SUBJECT: Staff Study, Proposed Technical Changes in the [REDACTED] Camera Calibrator Contract

Subject: Proposed technical changes
Reference: Contract [REDACTED] dated
19 June 1961, Article 8,
CHANGES, page 4.

Figure 2 (Revised 14 December 1961) TARGET ARRAY (1/2 SCALE)

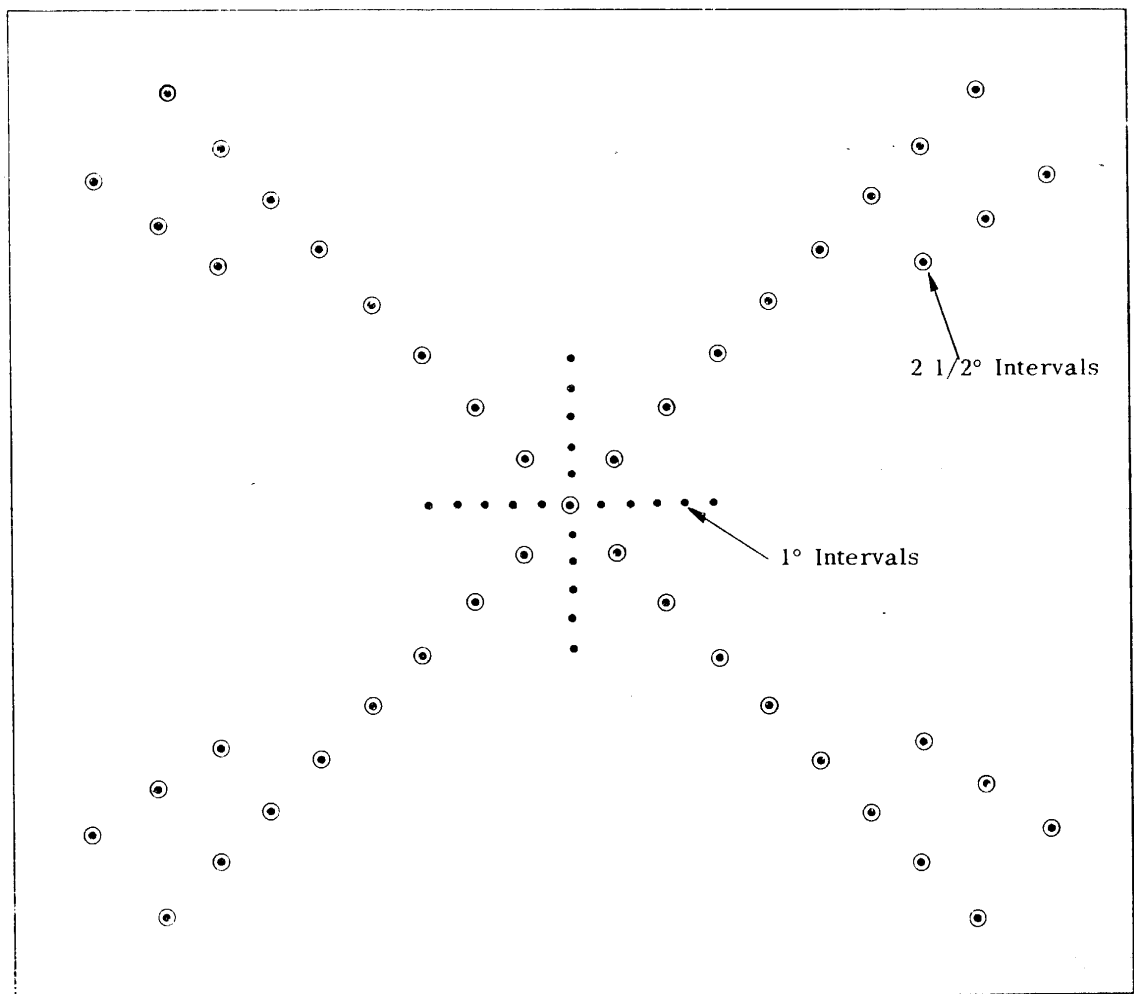
- i. Constant voltage regulator with standard three wire plug.
- j. Proposal Spec. Item b, delete "24 x 36 mm" and insert "square". See Figure 2 (Rev.).
- k. Proposal Spec. Item g, delete "45" and insert "49".
- l. Proposal Spec. Item n, delete sentence and insert "Place 12 additional targets at half-angles of 15°, 17 1/2°, and 20° on diagonals of a rectangular format to accommodate cameras with a 24 x 36 mm format." See Figure 2 (Rev.).
